28F200BV/CV 28F002BV SPECIFICATION UPDATE

Release Date: February 1998

Order Number: 297612-005

The 28F200BV/CV and 28F002BV may contain design defects or errors known as errata. Characterized errata that may cause the 28F200BV/CV and 28F002BV's behavior to deviate from published specifications are documented in this specification update.

A. t_{WHEH} - CE# Timing Erratum

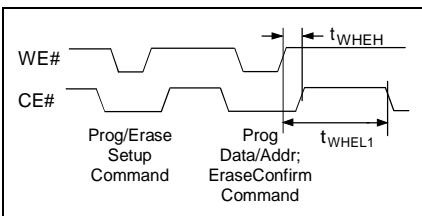
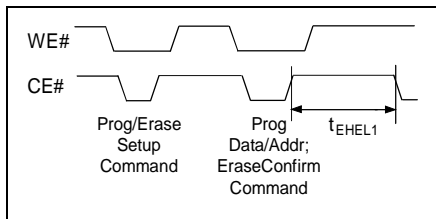
Due to a logic timing problem, new timing restrictions may be necessary between the WE# and CE# signals during write operations. The timing waveforms and specifications are shown below:

Affected Parameters for WE#-Controlled Writes

Symbol	Parameter	Datasheet		Errata		Units
		Min	Max	Min	Max	
t_{WHEH}	CE# Hold Time from WE# High	0	no spec	0	5	ns
t_{WHEL1}	CE# Pulse Width High from WE# High	no spec	no spec	110		ns

Erratum timing for t_{WHEL1} , given above, is required only after the second WE# pulse in a WE# controlled write sequence.

Basically, these new errata specifications for WE#-controlled writes require the system timing to:

1. Take CE# to logic high no earlier than WE# goes high and no later than 5 ns after WE# goes high.
2. Hold CE# high for at least 110 ns, starting from the time WE# goes high.

These timing specifications must be met for proper operation of the device. The flash memory chip select must go inactive within 5 ns of a program/erase operation and remain inactive for a period of 110 ns before going active again. Consider the following options for meeting the t_{WHEL1} or t_{EHEL1} requirement :

1. Follow a program/erase two-write sequence with an access to another memory so as not to decode the flash memory chip select for the required period of time.
2. Insert one or more no-op commands following a program/erase two-write sequence, again to ensure the flash memory chip select is disabled for the required period of time.

Depending on your system implementation, the t_{WHEH} requirement may require additional logic to ensure the required t_{WHEH} timing. Evaluate your system timing to ensure the new write requirements can be met. This erratum has been fixed in B-step material.
